**Re: *Joint Livingston Restoration Group (LRG) and BNSF Railway Company (BNSF)  
Submittal – Addendum to Final Air Sparge/Soil Vapor Extraction Pilot Test Work  
Plan***

**Subject: Addendum to Final Air Sparge/Soil Vapor Extraction Pilot Test Work Plan  
Burlington Northern Livingston Shop Complex; Livingston, Montana**

<b>AS/SVE EXPANSION PLAN</b>	
	<i>Proposed Well Locations</i>	
	Job#: LRGM01 Task 8	<b>FIGURE 1</b>
	Date: 11/9/2016	
Path: M:\LRGM01\Task8\AS/SVE_Expansion.mxd, Author: jleprosse

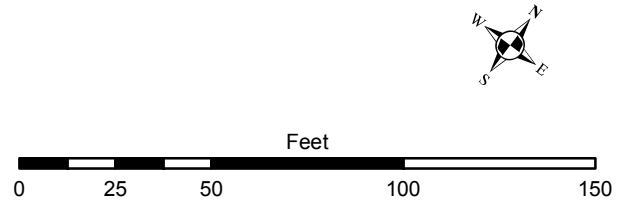
With this letter, Water & Environmental Technologies, Inc. (WET) is requesting approval to expand the existing Air Sparge/Soil Vapor Extraction (AS/SVE) system as described in the Final Air Sparge / Soil Vapor Extraction Pilot Test Work Plan (Work Plan), dated September 23, 2015 (Figure 1). The purpose of the expansion is to adapt to the localized flow path, improve treatment of the center of plume, and provide better flow-line monitoring to quantify mass removal rates.

12 AS wells will be installed. Included will be two rows of 4 and 5 extending the sparge curtain approximately 150 feet north of the current system (Figure 1). Also, two wells will be installed at the southern end of the current system to extend the reach of the system. In addition, a single well will be installed upgradient of the bend in the curtain within the central portion of the peak concentration flow path. Finally, one SVE well will be installed near the northern end of the expansion. The northernmost SVE well from the existing system (DG-SVE-1) and the northernmost AS wells (DG-AS-2, DG-AS-3, and DG-AS-9) will manifold to the expansion system shed to balance flows between the two systems and improve overall air delivery. This will improve overall capture radius of the existing system and generate improved capture radius for the northern system. The new AS wells and SVE wells will be installed in accordance with the September 23, 2015, Work Plan.

In addition to system expansion wells, seven groundwater monitoring wells will be installed. Two wells will be installed upgradient of the northern extension of the expansion, four downgradient including one on the bend in the expansion, and one south of the existing system and south of the MRL access road. The southern well will provide additional performance monitoring and assist in establishing concentrations at the southern end of the treatment area. Northern performance and plume extent monitoring will be determined using existing well 89-7, located approximately 50 feet north of the expansion air sparge wells. New monitoring wells will be single completion wells and will be constructed in accordance with monitoring well construction details described in the September 23, 2015, Work Plan.
